**Supplement to
Red Hill Bulk Fuel Storage Facility
Administrative Order on Consent
Tank Upgrade Alternatives and
Release Detection
Decision Document**

**August 2021
Navy Region Hawaii**

Red Hill Administrative Order on Consent Tank Upgrade Alternative (TUA) and Release
Detection (RD) Supplemental Document Deliverable

Section 3.5 TUA Decision Document and Implementation

RFI 1 Figure 1: Bow-Tie Diagram for Alternative 1A – Environmental Risk Management

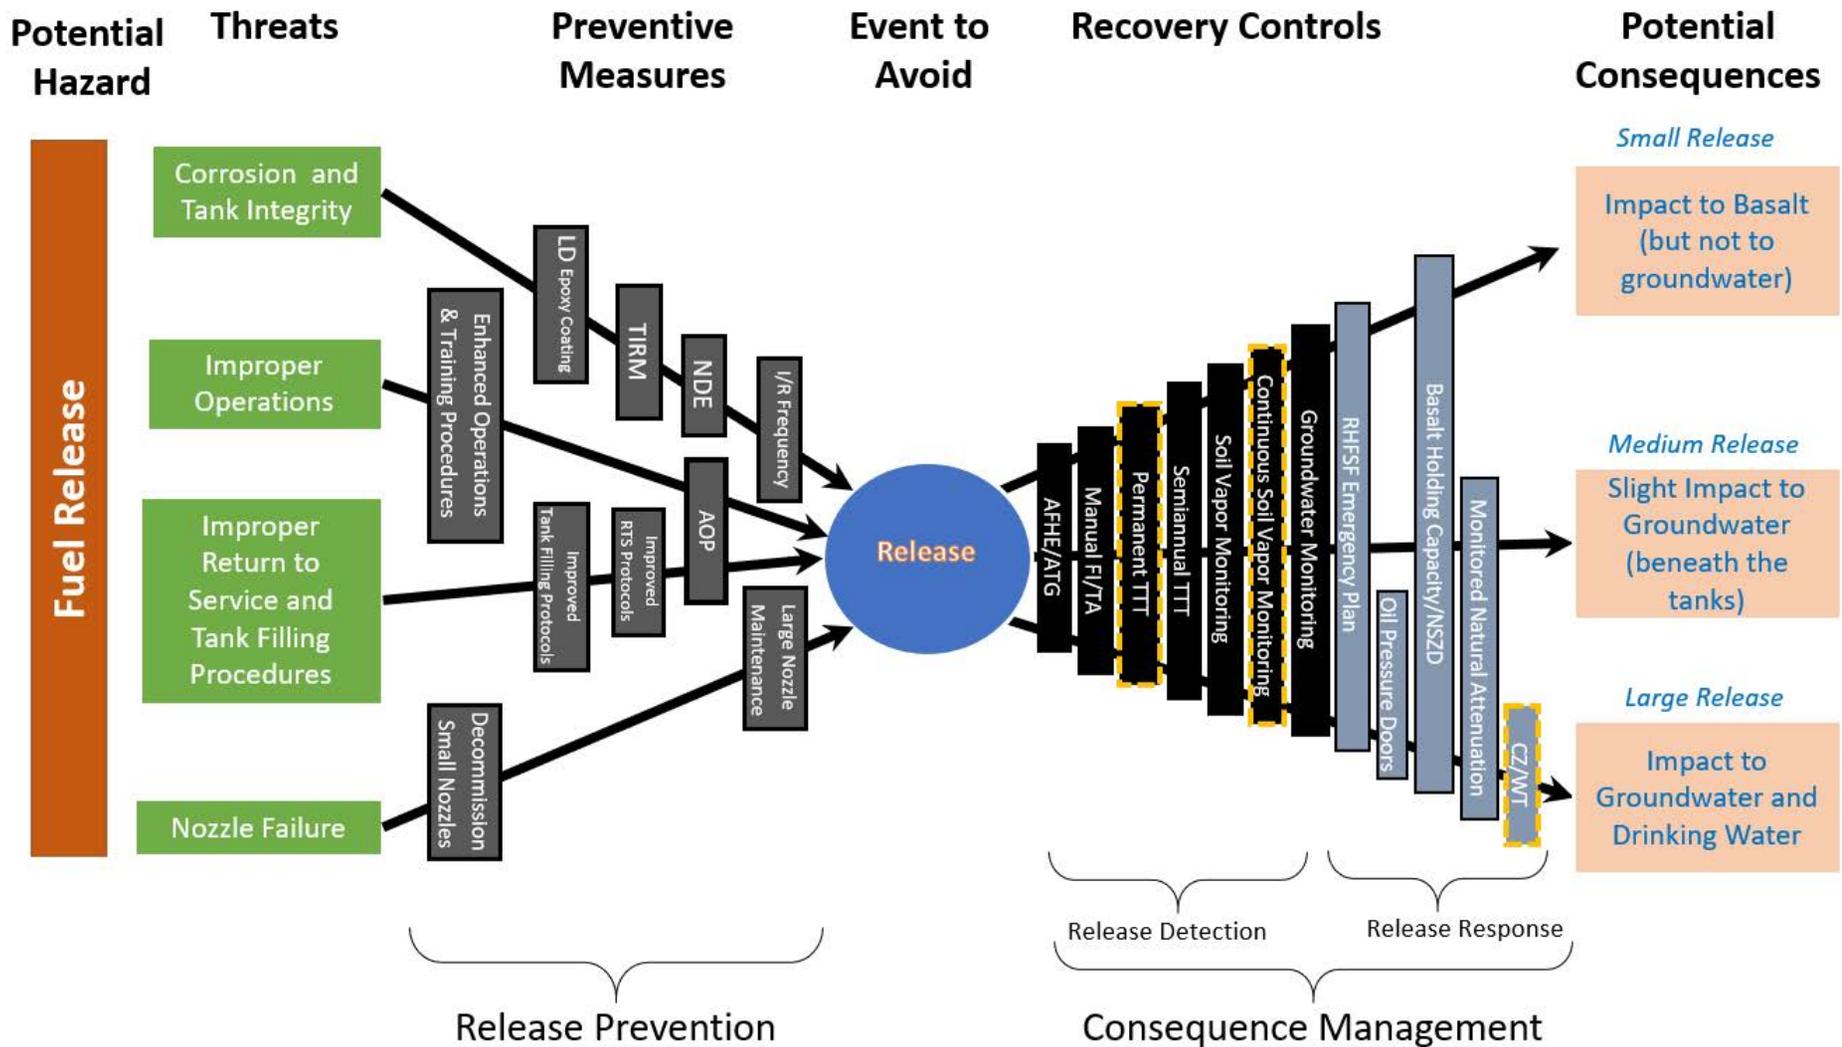
Regulatory Agencies' Comment:

The Navy has developed a bow-tie diagram (RFI 1 Figure 1) to describe how all elements of release prevention, detection, and release response measures are holistically integrated to protect groundwater. A bow-tie diagram helps to visualize a risk event (such as a release of fuel) along with its root causes, consequences, and risk prevention, detection, and mitigation measures. Use of this tool started in the petroleum industry and is now a widely used tool for risk management throughout a variety of industries. All these elements are described in detail both within this Response to RFI 1 as well as in all subsequent RFIs. As part of this analysis, potential threats relating to a hypothetical release include corrosion and tank integrity, improper operations, improper return to service and tank filling procedures, and nozzle failure. Various release prevention barriers are shown on each threat line and are discussed in this and subsequent responses to RFIs. This demonstrates the steps that the Navy is taking toward ensuring that potential releases are prevented from occurring.

The bow-tie diagram presented on RFI 1 Figure 1 *ties together* and visually describes the various layers of protection currently being used and being planned by the Navy for protection of groundwater and drinking water.

The bow-tie diagram presented on RFI 1 Figure 1 describes how all elements of release prevention, detection, and release response measures are fully integrated to protect groundwater and drinking water resources. All these elements are described in detail in the Responses to RFIs in this Supplement to the TUA Decision Document.
